Administrative Approval Action

Wake Tech Automotive and Collision: SR-49-18,
Transaction# 556411, AA#3864

Design Adjustment Staff Response

REFERENCE: Design Adjustment for SR-49-18 WTCC Automotive & Collision

Figure 1 – Block Perimeter

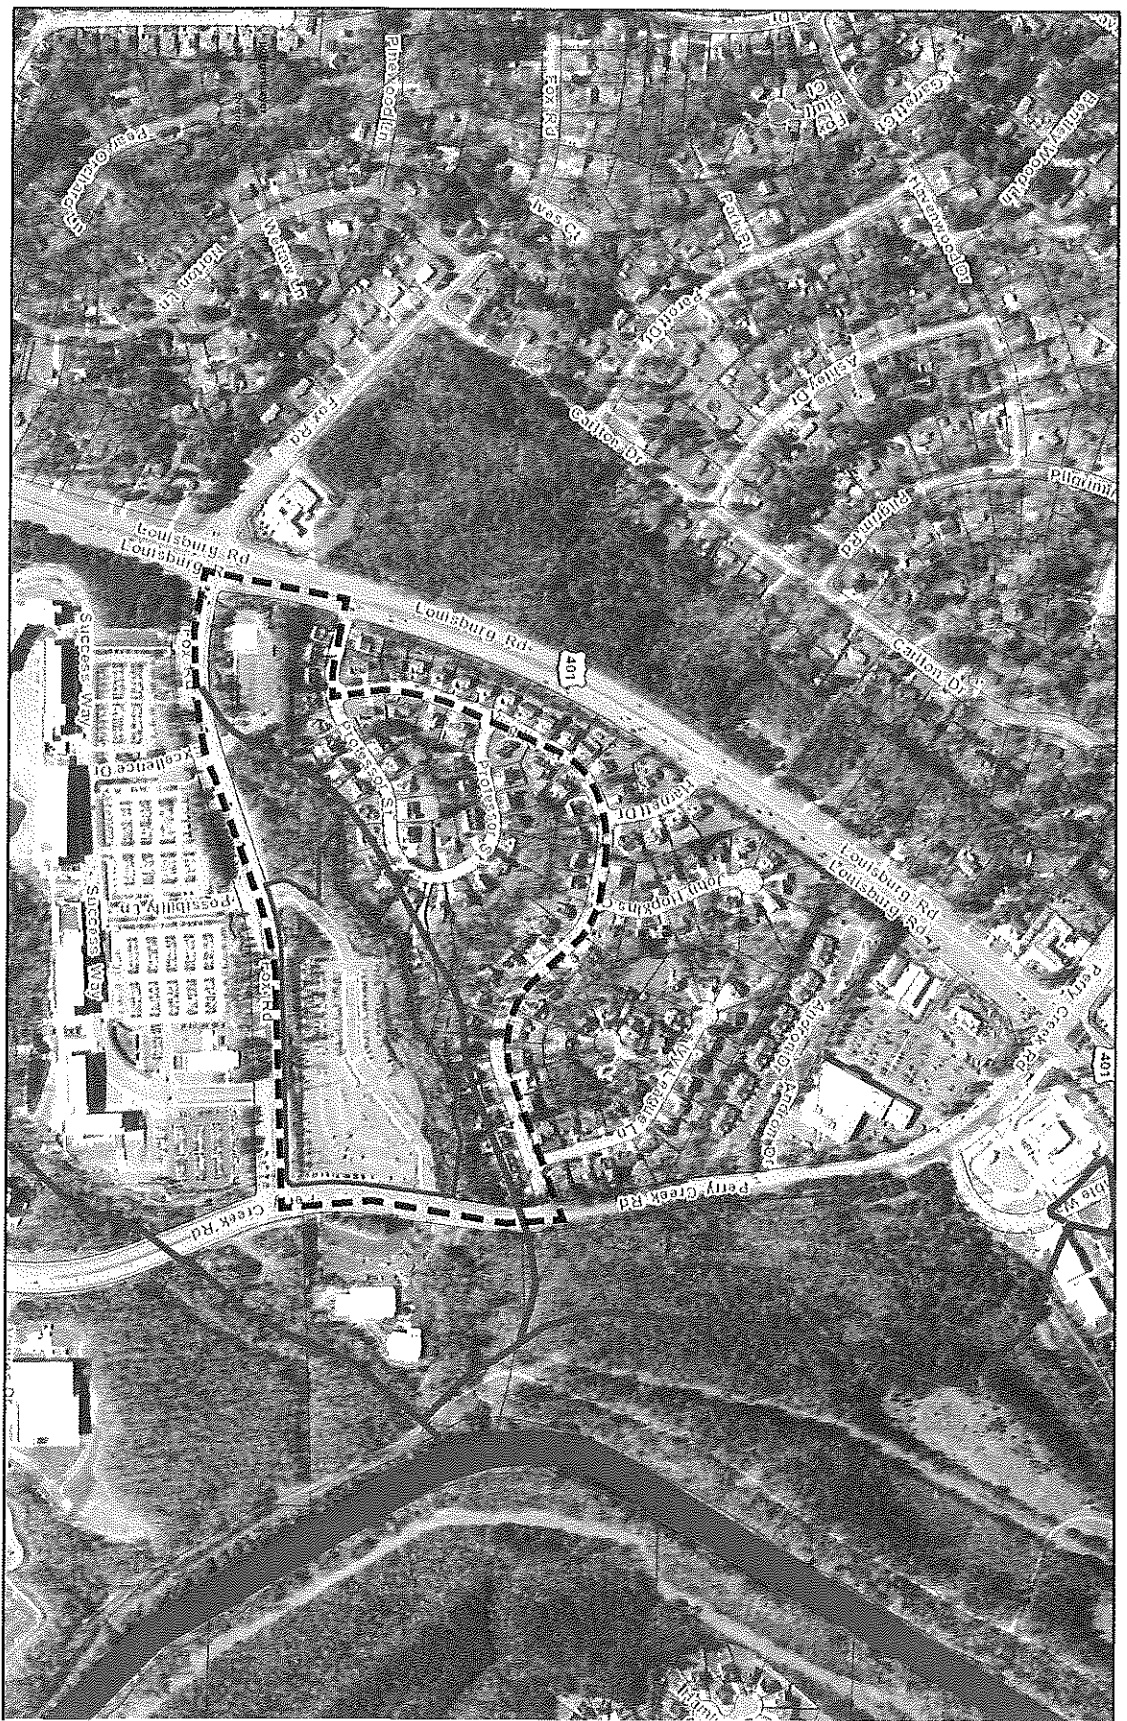
The parcel at 6851 Perry Creek Road is split zoned with the R-10 zoning being the most restrictive block length at 2000 feet. The measured block for this parcel is approximately 5800 feet.

The proposed development will have a privately maintained shared access drive with access onto Perry Creek Road and Fox Road. The private access drive cannot be considered for code compliance in measuring the block. However, the drive effectively spans the length of the development creating a shorter travel length of approximately 2800 feet around the development.

The existing topography, surrounding developed properties and environmental features limits the ability to construct public street connections that would create a compliant block length. Staff supports the design adjustment.
